## ADDENDUM #2

Date: 07/01/2024

Project: Reroofing Project for the  
Merrillville Community School Corporation  
6701 Delaware Street  
Merrillville, Indiana 46410  
Architect's Project # 24013

SHEET  
**A**  
3.4.0

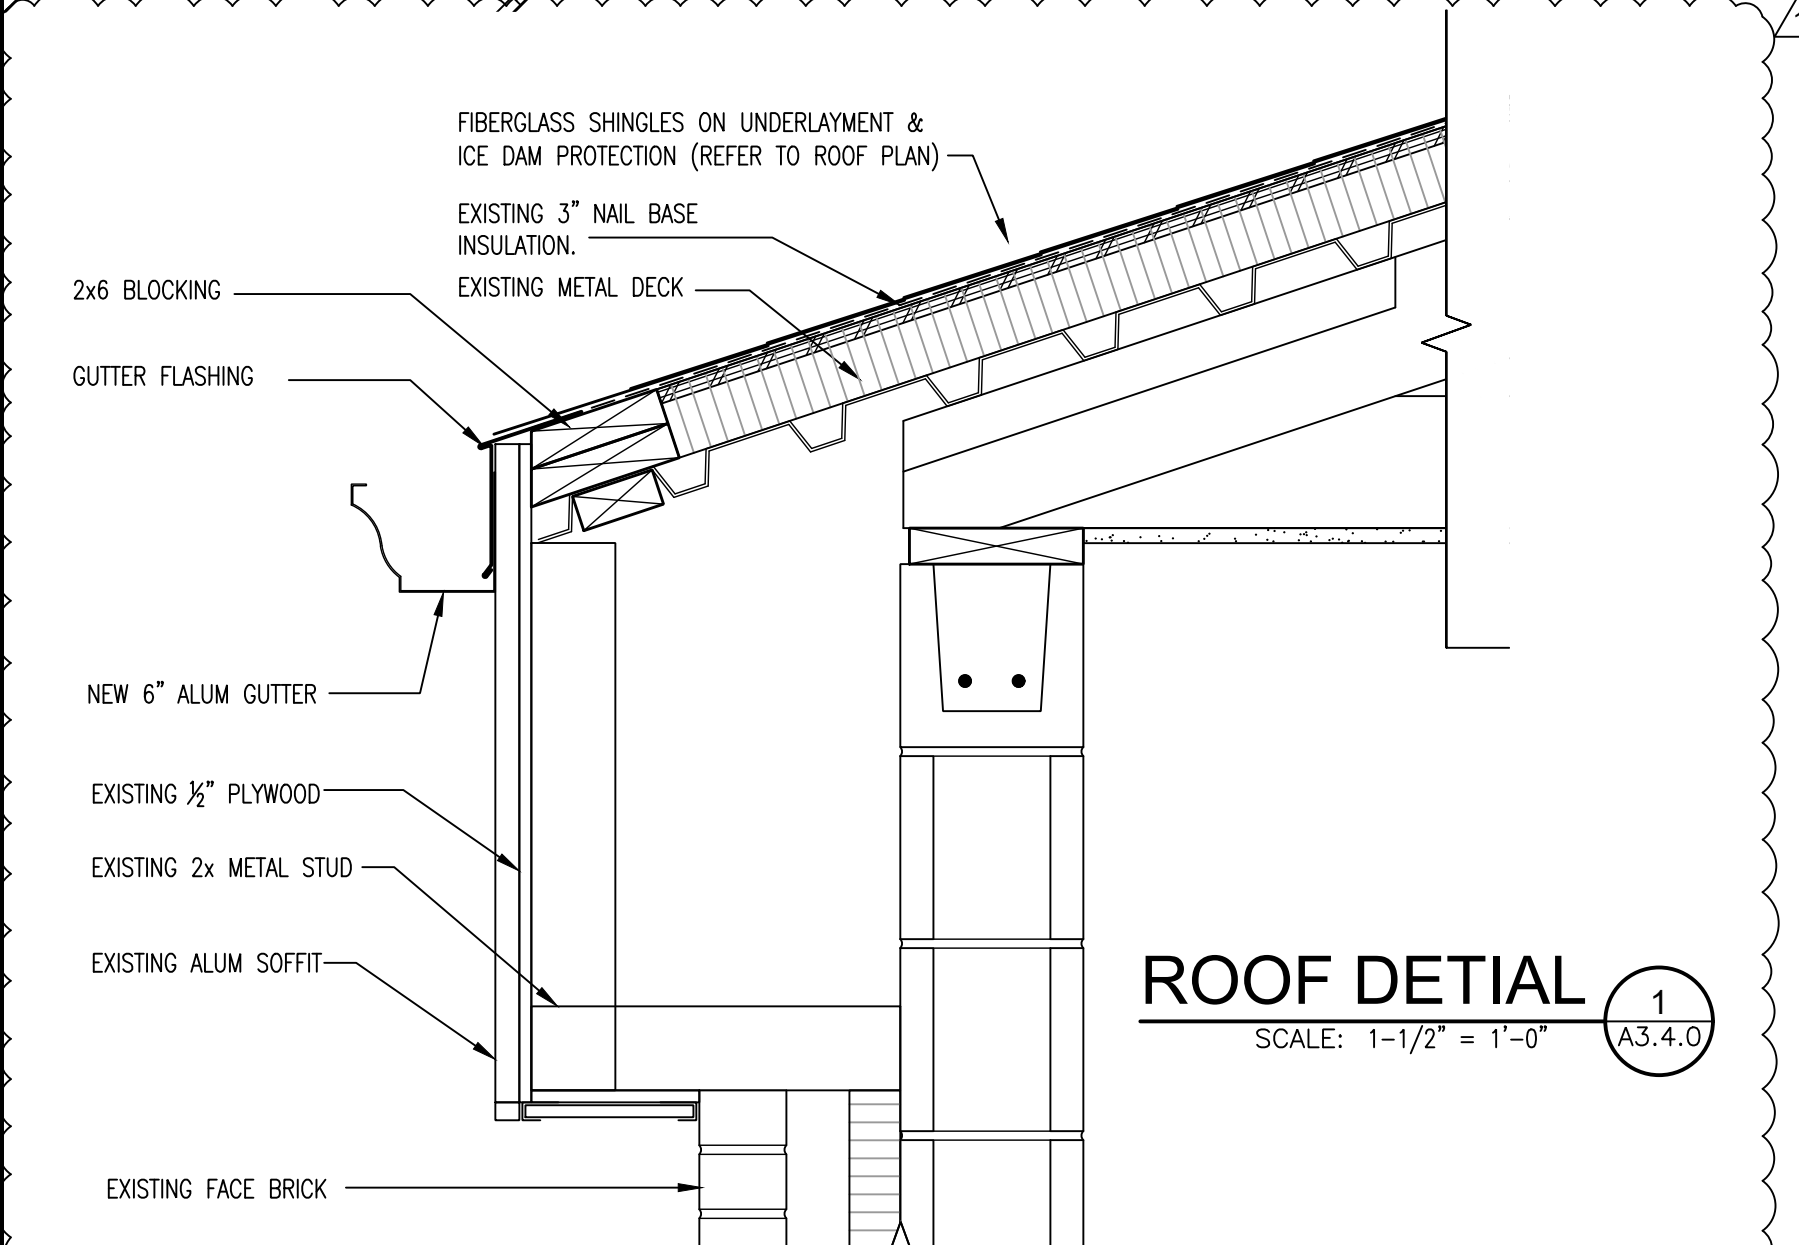
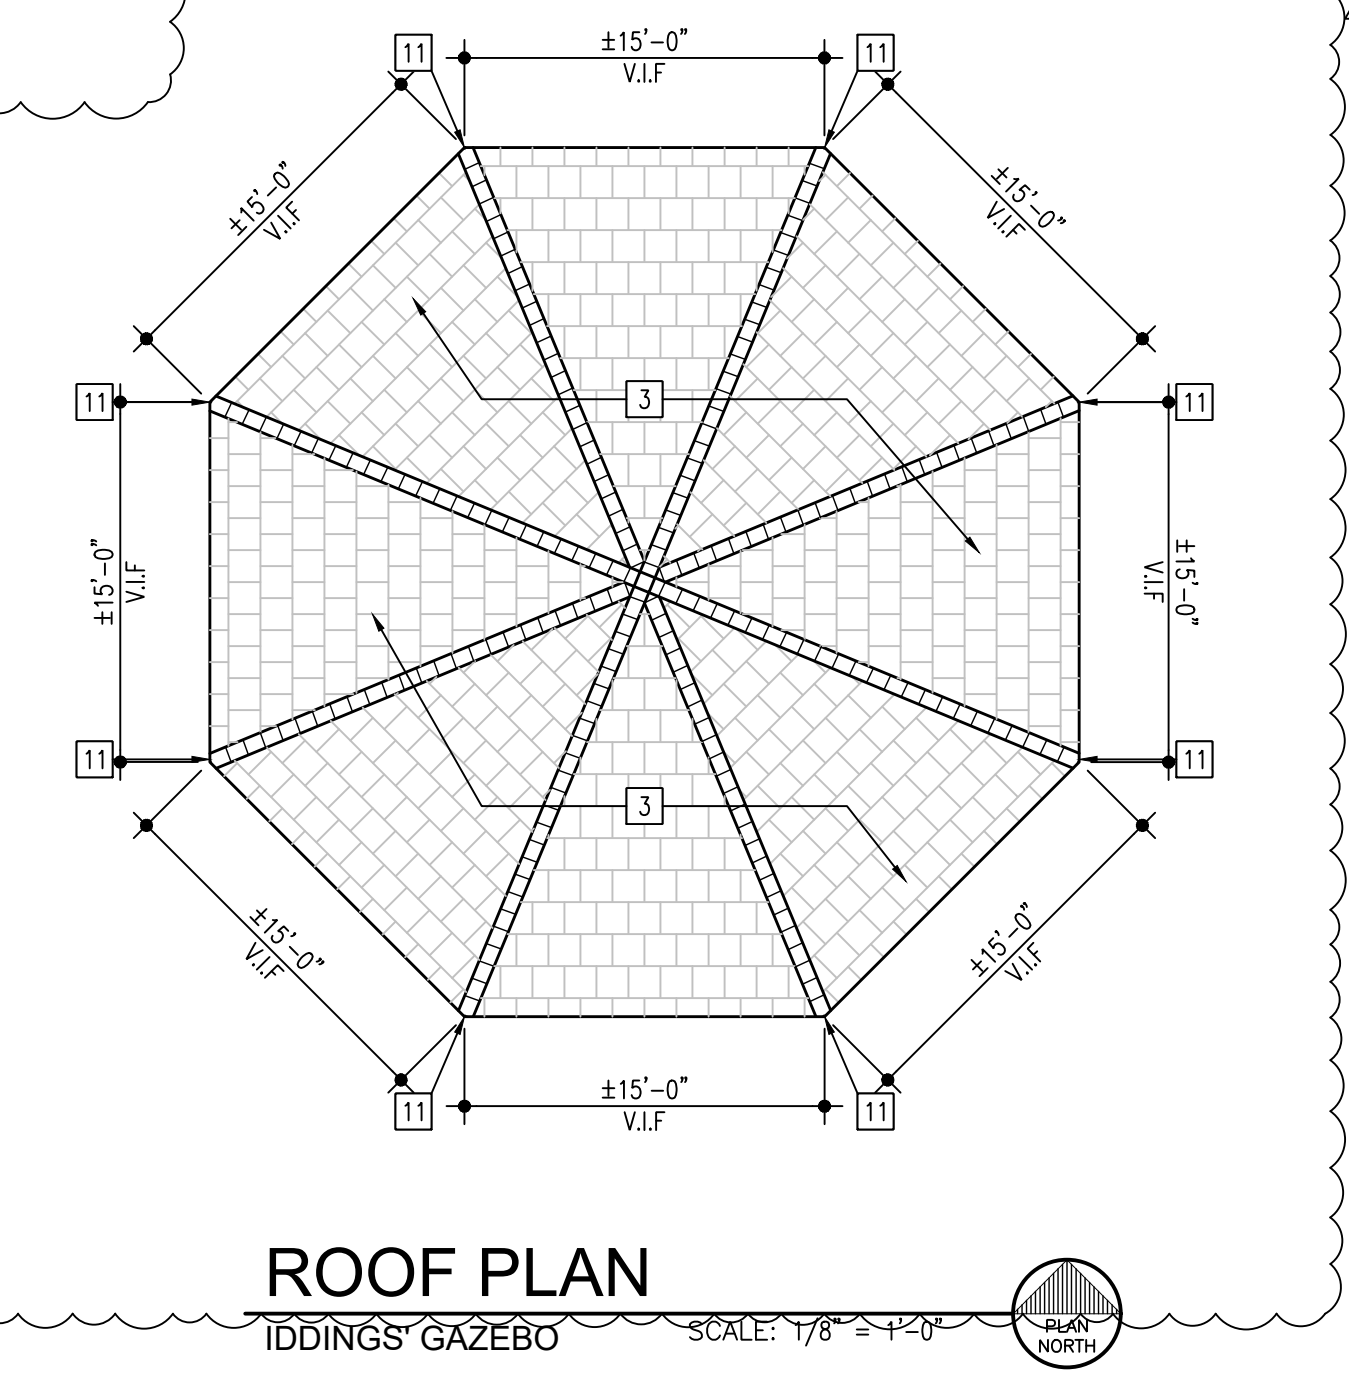
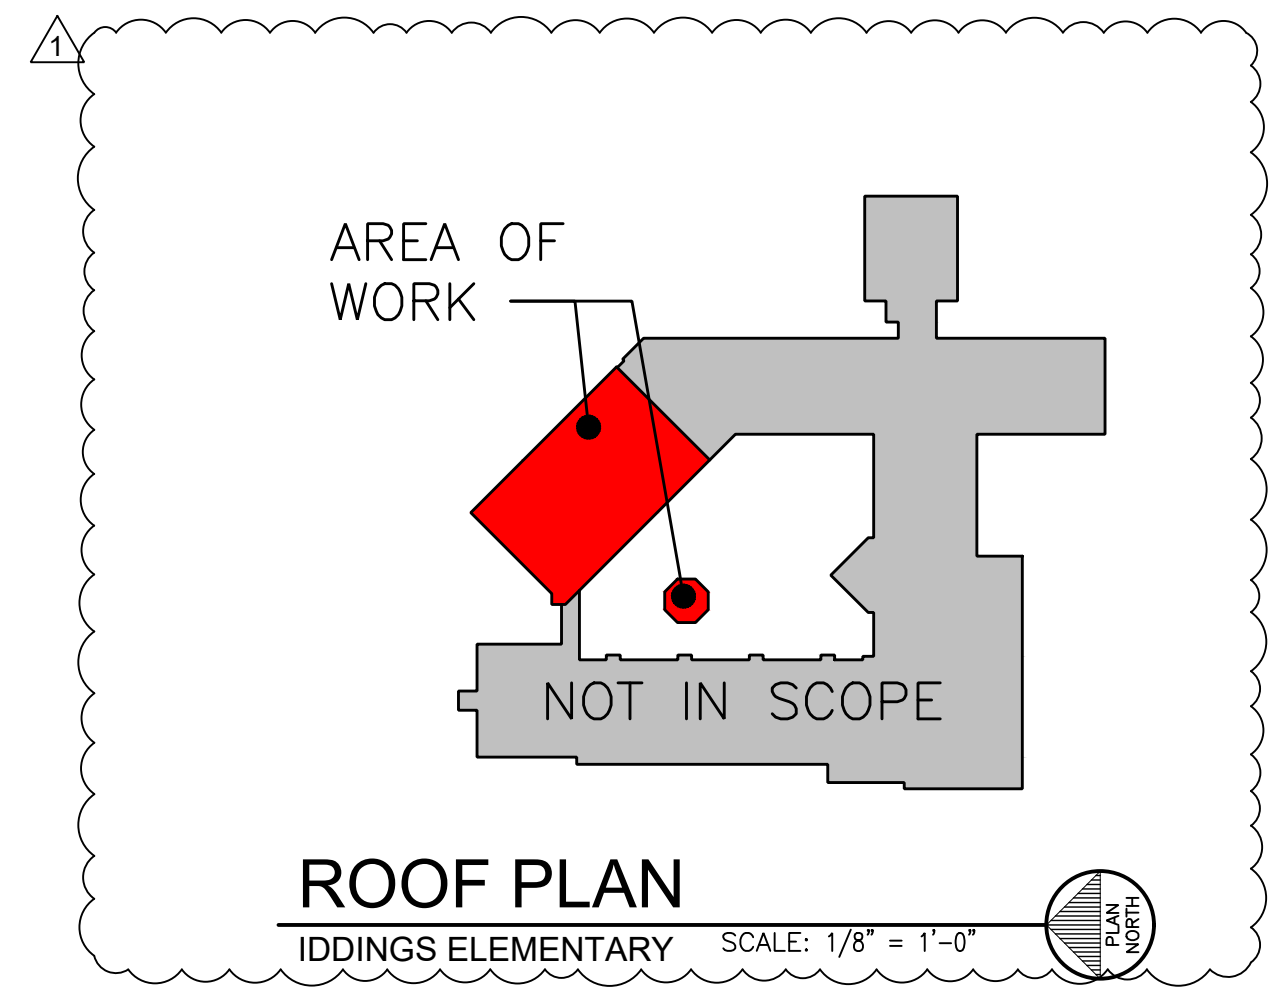
10. See attached Revised Drawing Sheet A3.4.0 – Roof Plan – Iddings Elementary – This plan shows clouded and tagged revisions dated 07/01/2024.
